REQUEST FOR RECONSIDERATION OF HEARING EXAMINER FINAL DECISION,
Dated 8-25-16

RE: Elliott Farms

Preliminary Plat

LUA15-000242, ECF,PP,SA-H,MOD

OFF-SITE ANALYSIS DRAINAGE SYSTEM TABLE

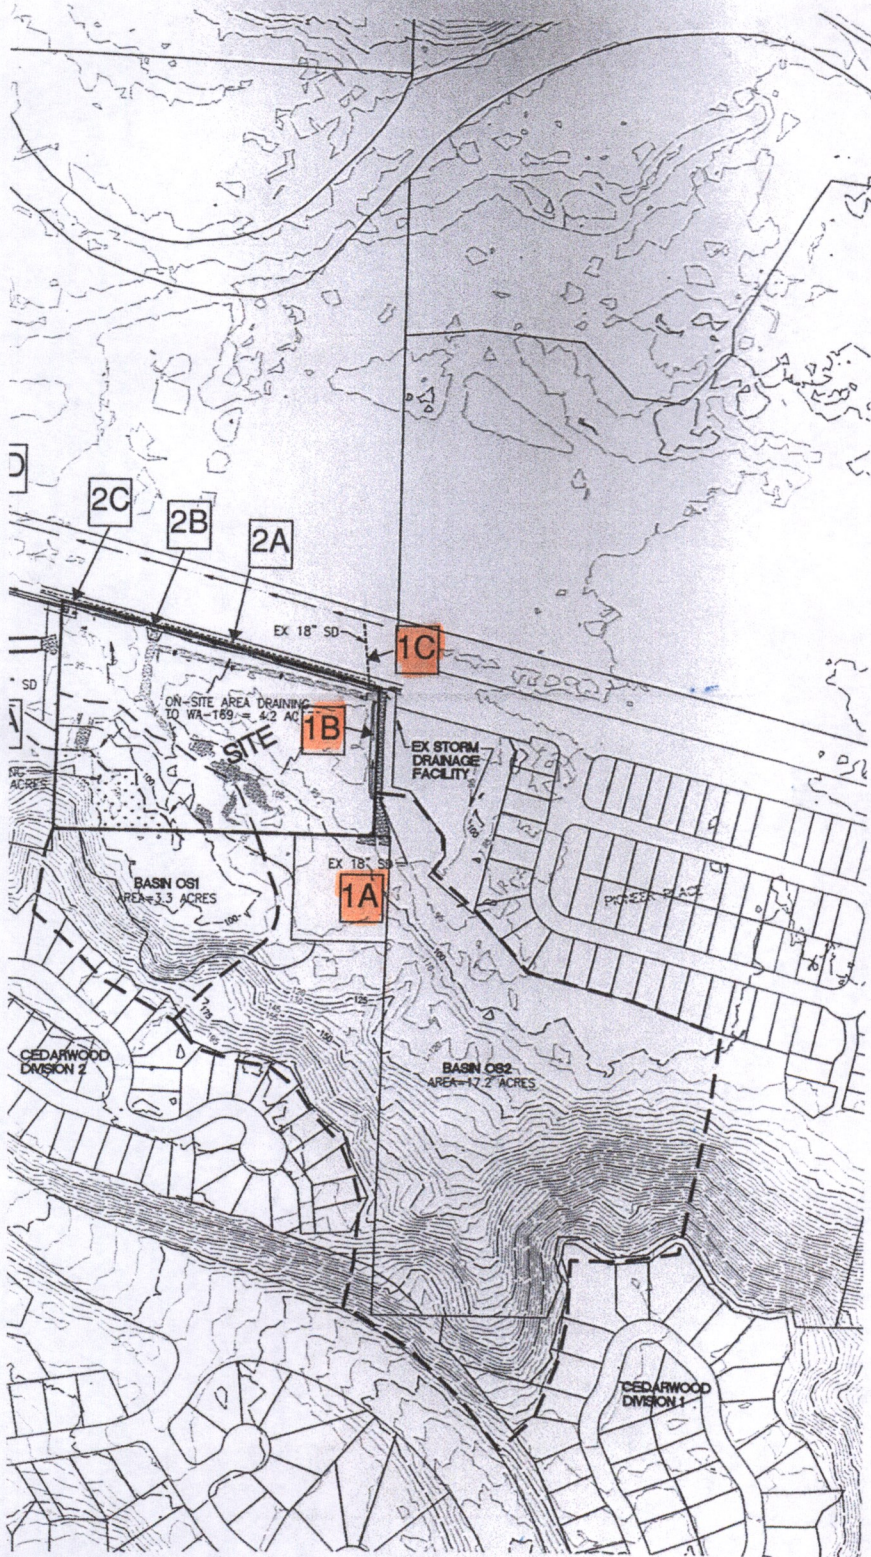
Under Task 3 of the Upstream Drainage Area, it does not state that the drainage collected in the ditch and conveyed to an 18" culvert crossing WA – 169 is first collected on the east side of the road into our property and then runs through a culvert under the road to reach the ditch, but this is noted in the System Table under Location 1A.

The main item that is missing from this report is that the overflow from the retention pond for Pioneer Place Homes also drains into this area. Once the main part of the pond fills, the overflow area fills and then the water starts flowing into the area east of
